Product Change Notification - SYST-13IXOV452

ERRATA - PIC32MK Motor Control and General Purpose Errata and Data Sheet Clarification

Description of Change: Updated Silicon issue 58. Module: USB to remove the word “host”, which broadens the scope of the errata to pertain to both Low-Speed Host and Device Modes.

PIC32MK General Purpose and Motor Control (GP/MC) Silicon Errata and Data Sheet Clarification

FIGURE 1: Posc CRYSTAL CIRCUIT

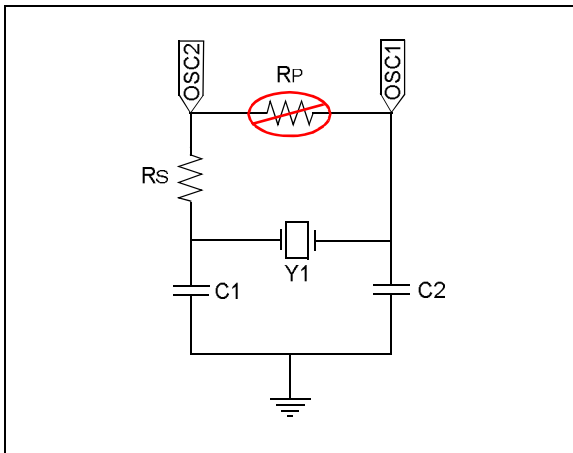
The Posc supports only specific crystal operation, as provided in [Table 1](#).

The Primary Oscillator (Posc) has been characterized to operate at 8 MHz and 12 MHz when the circuit shown in [Figure 1](#) is implemented and the operating conditions provided in [Table 1](#) are met.

Crystal Frequency (see Note 1)	Series Resistor Rs	Posc Gain Setting POSCGAIN<1:0> (DEVCFG0<20:19>)	Posc Boost Setting POSCBOOST (DEVCFG0<21>)
8 MHz	2 kΩ	'0b00 (GAIN_0)	'0b1
12 MHz	1 kΩ	'0b00 (GAIN_0)	'0b1
24 MHz ⁽³⁾	0	'0b00 (GAIN_0)	'0b1

2: A parallel resistor (RP) should not be used to increase the gain of the Posc.

3: Only 24 MHz crystals with a Mfg ESR ≤ 40Ω.

FIGURE 2: RESET SUPERVISOR CIRCUIT

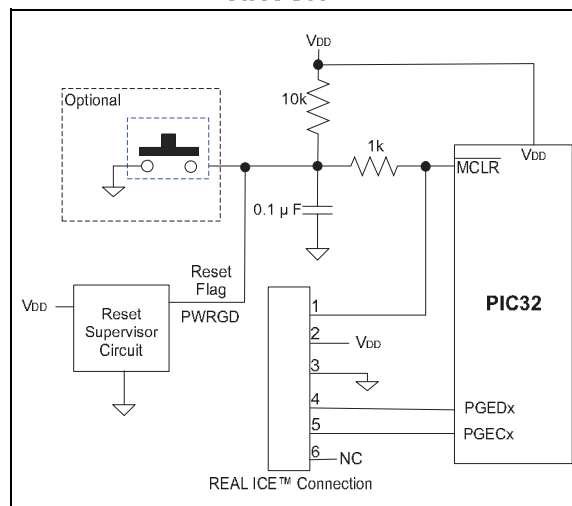
On a BOR event, $V_{POR} < V_{DD} < V_{BOR}$, a Reset is not generated when the BOR threshold is reached. System clocks will stop with all I/O pins functions frozen in their present state until either V_{DD} falls to V_{POR} or V_{DD} returns to above V_{BOR} . The user must assess if this V_{DD} brown-out condition and the resulting frozen I/O pin state has an adverse effect on their application (UART, PWM, I/O, OC, etc.).

Use an external Reset supervisor/monitor (see Figure 2). Some LDO regulators, as listed in Table 4, have an embedded reset supervisor included. The required minimum reset trip voltage of the supervisor should be at least ($V_{BOR} + 0.5V$) with the SMCLR bit (DEVCFG0<15>) = 0 and the BORSEL bit (DEVCFG2<29>) = 1 in the Configuration Words. This means that the minimum V_{DD} operating voltage of the application needs to be above the reset supervisor maximum trip voltage at [Reset Trip (max) + 0.2V], (i.e. Application $V_{DD(MIN)} = \sim(V_{BOR} + 0.5V + 0.2V)$). The reset supervisor should have an open drain output so as not to interfere with the MPLAB

programming/debug tools. This workaround assures that MCLR will generate an internal POR and reset the I/O pins before the V_{BOR} trip point.

Note: For Motor Control applications utilizing the PWM module, **only Work around 1 is recommended.**
